NOTICE 07-001

It has come to the attention of the Foundation that some of the following Conbraco backflow prevention assemblies have been sold with check valve springs manufactured out of tolerance and are not approved. The assemblies affected include the following:

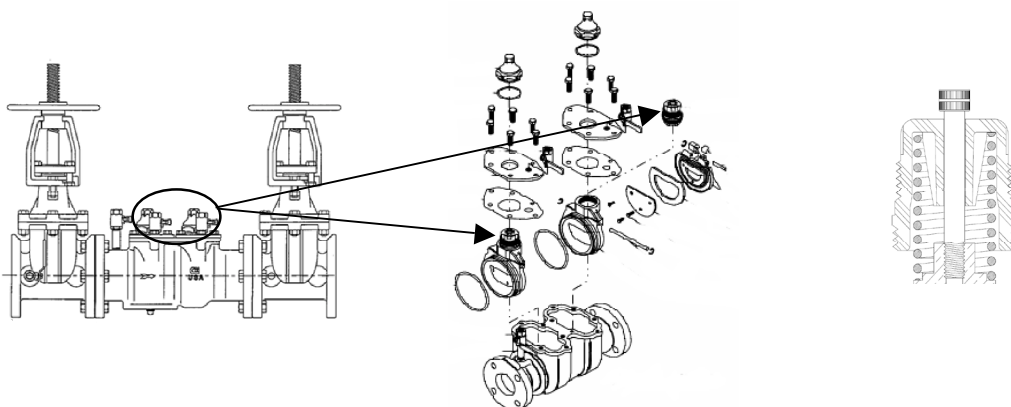
The improper check valve springs have too many spring coils, which will restrict the check valve clappers from opening to their normal fully open position. This will cause a higher pressure loss through the assembly at the flow rates above approximately 500 gpm. The springs are contained in the spring assembly modules for each check valve. (Note: Warning from Conbraco repair manual: The check valve spring is held in compression by the retainer bolt. The spring assembly should not be disassembled as serious injury could occur. The spring assembly is sold as a pre-loaded unit.)

The same spring module is utilized in all the sizes noted above, however, only the 6-inch assembly has a rated flow rate (Table 10-1, Manual-9th Ed) above 500 gpm.

Should you have an assembly affected by this situation please contact Conbraco at (704) 841-6000 for replacement spring assembly modules.
